COUNCIL ASSESSMENT REPORT

SYDNEY EASTERN CITY PLANNING PANEL

PANEL REFERENCE & DA NUMBER	PPSSEC-143 – DA/437/2021
PROPOSAL	Demolition of buildings, works to the Coogee Bay Hotel, including refurbishment to provide for 18 hotel rooms, a new 3 storey building to the southern side of the beer garden with 13 new hotel rooms (resulting in a total of 31 hotel rooms), construction of a 5/6 storey shop top housing comprising 58 dwellings, 11 retail premises, internal laneway from Coogee Bay Road, basement parking for 159 spaces, subdivision, landscaping and associated works (Local Heritage Item, variations to FSR and height of buildings of the RLEP 2012, Integrated Development).
ADDRESS	Lot 1 DP 872553 – 212 Arden St Lot A DP 437308 – 227-233 Coogee Bay Rd Lot B DP 437308 – 5-7 Vicar St Lot A DP 337724 – 15A Vicar St
APPLICANT	Cotton Development Management Pty Ltd c/- Urbis
OWNER	Simmattown Ltd
DA LODGEMENT DATE	22 July 2021
APPLICATION TYPE	Integrated Development Application

Figure 7: Excerpt of Section AA (Drawing No. DA250 prepared by Fender Katsalidis)

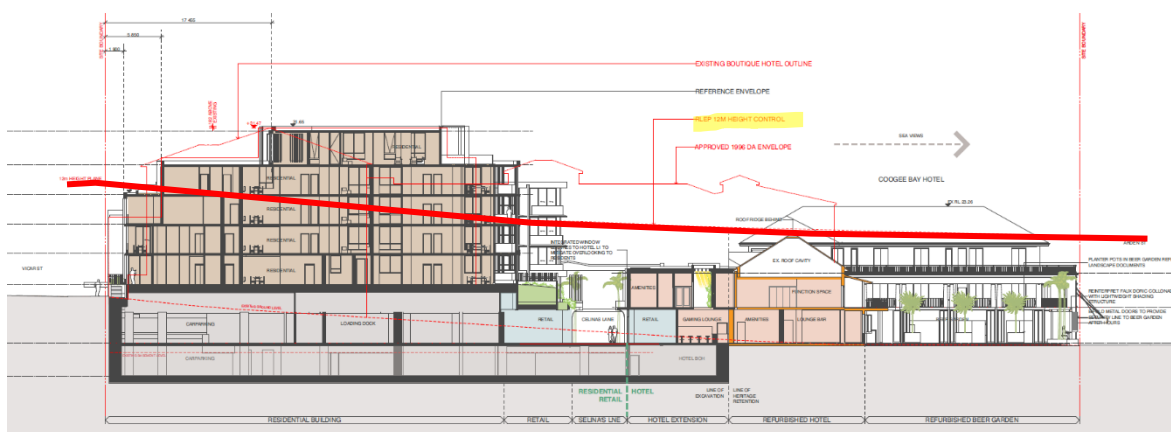
Pursuant to Clause 4.3 of RLEP 2012, a maximum height of 12m applies to the subject site. The proposal seeks a maximum overall building height of 21.35m (78% variation). The following section and massing diagrams show the height exceedance indicated by the superimposed red line(s).

Clause 4.3(2) of the Randwick Local Environmental Plan 2012 (RLEP 2012) states that *the building height for a building on any land is not to exceed the building height shown for the land on the Building Height Map* which indicates 12.0m. The proposed development has a maximum height of 21.35m, exceeding the development standard by 9.35m or 78%.

In consideration of the applicant's written submission, Council is satisfied that it is unreasonable or unnecessary to require strict compliance with the height of buildings development standard under Clause 4.3(2) of the RLEP 2012, in that the development achieves the objectives of the standards, and there are sufficient environmental planning grounds to justify contravening the height of building standard.

Figure 9: 3D Massing – 12m Height Overlay (Source: Drawing No. DA417 by Fender Katsalidis)

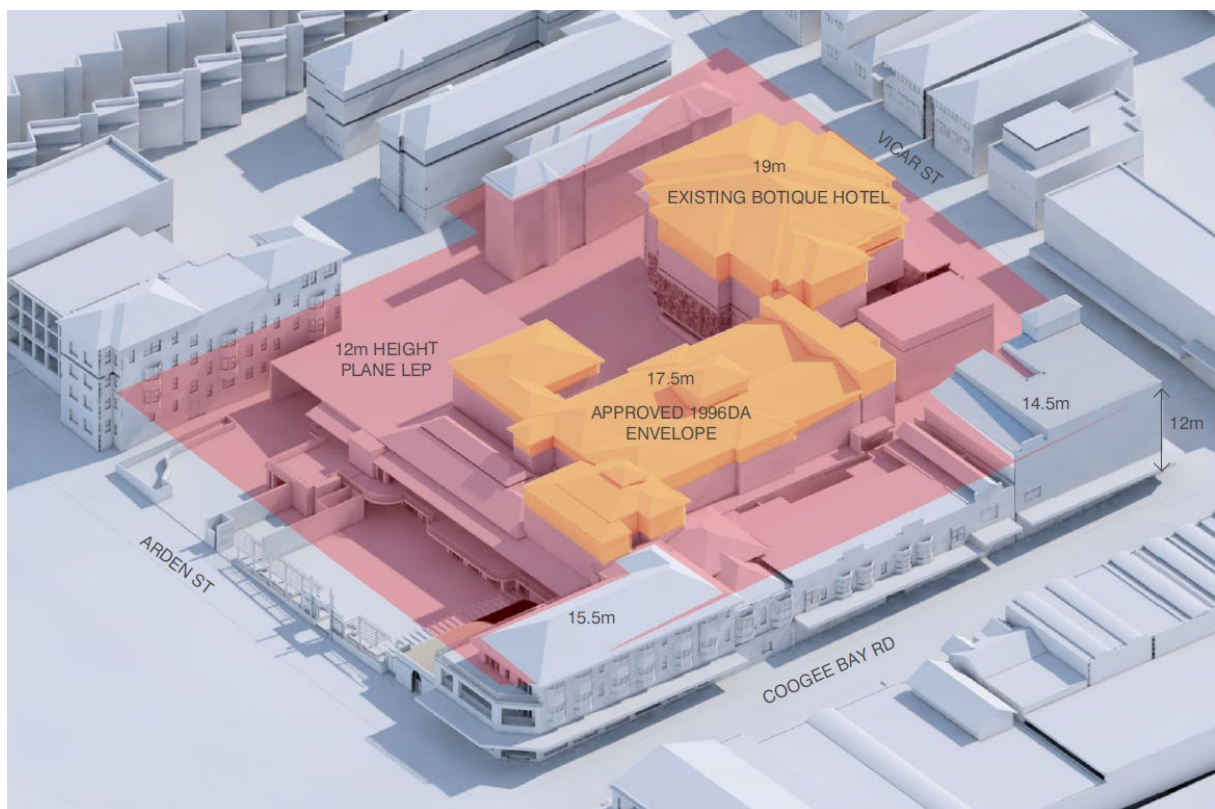
The exceedance of the 12m height control is also demonstrated in the 3D massing diagrams provided below (Figure 9), which show the parts of the existing building envelope; massing of the previously approved development (DA599/95); and the extent of the new shop top housing building, which is above the 12m height plane (Figure 10).

- Further, Figures 9 and 10 show that there is an existing non-compliance with building height on the corner of Coogee Bay Road and Vicar Street. The proposal (as amended) has positioned the northern-most wing to be setback from the street-front boundaries, to maintain the three-storey character immediately within the streetscape, with additional recessive design elements assisting in minimising the perception of bulk and scale from the public domain. Additional discussions between the Applicant and Council’s Urban Design Expert have informed how the massing has been massaged to provide an appropriate level of internal amenity, with the Applicant also undertaking an additional assessment into the potential for view loss resulting

Figure 12: Excerpt from Section AA with outline of existing Boutique Hotel and 12.0m building height line (prepared by Fender Katsalidis)

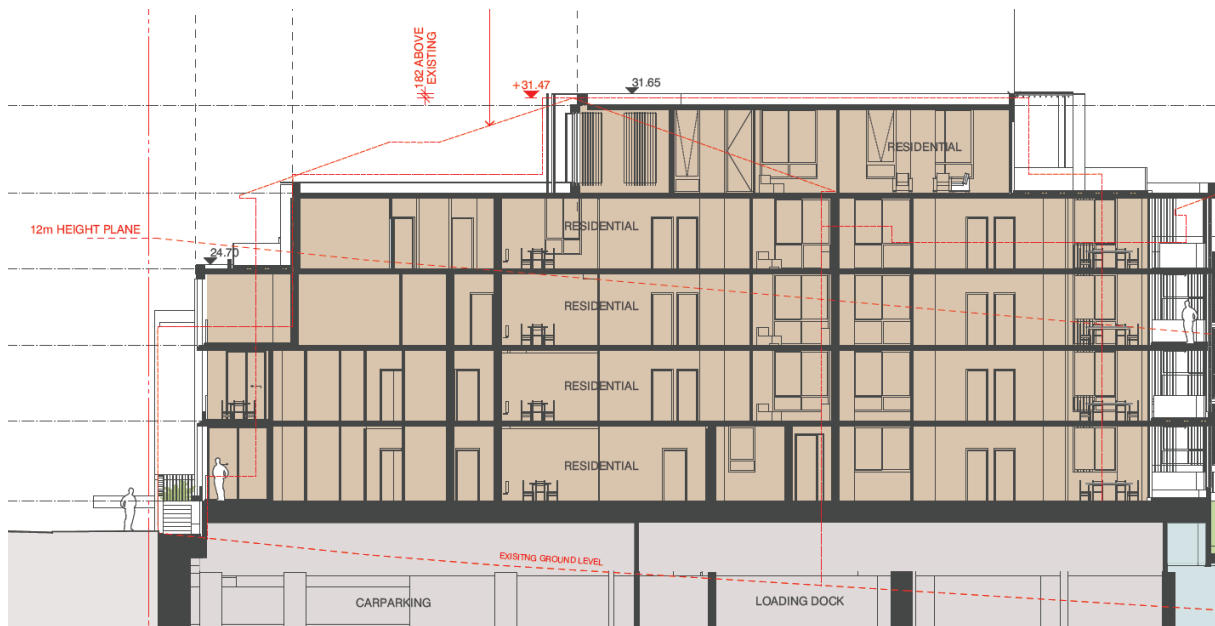
The resulting re-massing of height to the western component of the development is an appropriate contextual response for the development given the overall development site area, and constraints for development proximate to the heritage Hotel.

Further, the written request adequately establishes that the development does not dominate the streetscape when considered in its context, with the site being within the lower/basin of Coogee; and in consideration that the proposed form establishes a three-storey street front facade, which is consistent with the desired future character of the area.
